## Side Pannier Sliding Shoe Replacement

Multistrada 1200 MY 2015-2017 (all versions)  
Multistrada 1260 MY 2018-2020 (all versions)  
Multistrada 950 MY 2017-2021 (all versions)  
Service Repair Bulletin SRV-SRB-21-039

Service Repair Bulletin SRV-SRB-21-039

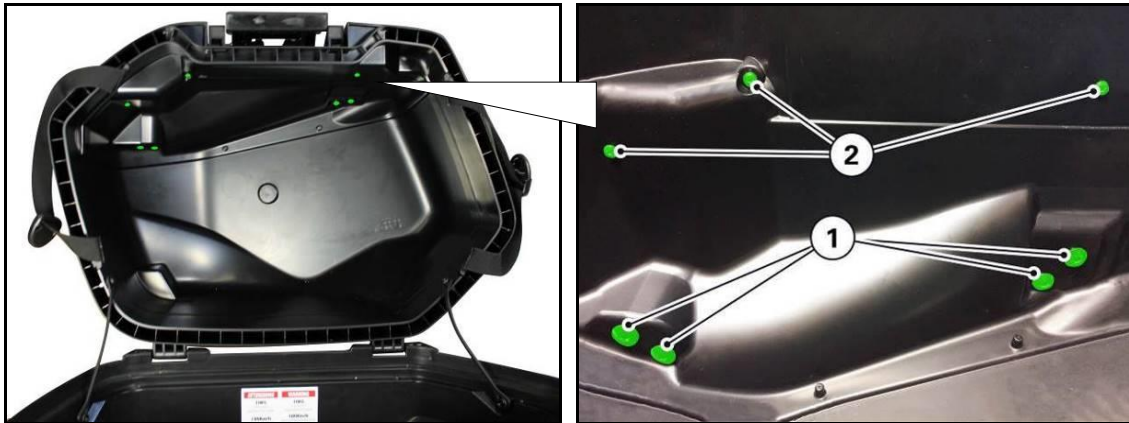
Although this is a very unlikely event, we would like to inform you that in order to prevent this issue from occurring, new sliding shoes have been installed on all side panniers manufactured from February 2021 with the date "21050" (50th day of 2021); the new sliding shoes can be easily recognized from the previous ones because of the presence of an arrow next to the letters "R" (Right) and "L" (Left).

RIGHT side pannier sliding shoe Part no. 69916791A	LEFT side pannier sliding shoe Part no. 69916801A
